Subject:

K 8
Technical Note
No. 24

Alexander Schleicher
GmbH & Co.
Segelflugzeugbau
XXXXX
D-6416 Poppenhausen

Poppenhausen, Dec.4, 1995

Fig. A2

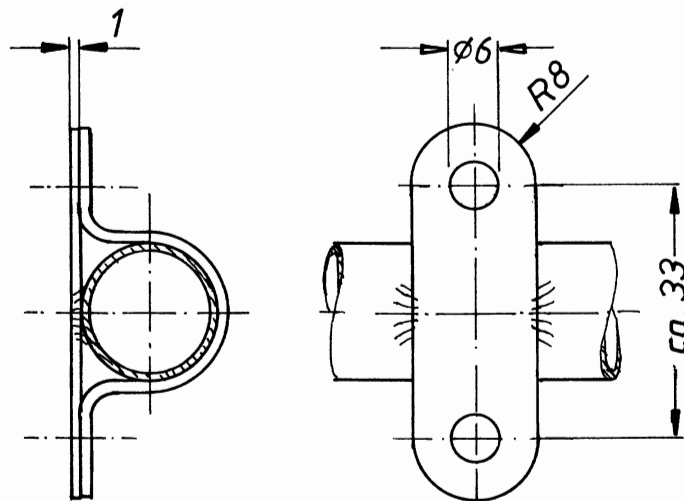
- ad A2) Checking the rudder pedals:
With the rudder neutral the pedals left and right must be evenly adjusted. Check the pedal board angle versus the pedal (dimensions see drawing L-216.42-U01). The angle must meet the specified dimension.
Engage the pedal adjustment into its foremost position and check full deflection of the rudder.
Where pedals or attachment collars are bent, these can be either repaired or replaced by new ones.
In order to impede the bending of the pedal boards it is optionally recommended to weld an additional butt strap onto the attachment collar (see Fig.A2).

Reinforcing the attachment collars for pedal boards at the pedal assembly. Material: 1.7734.4

Welding procedure WIG to spec DIN 1912, welding wire material: 1.7734.2
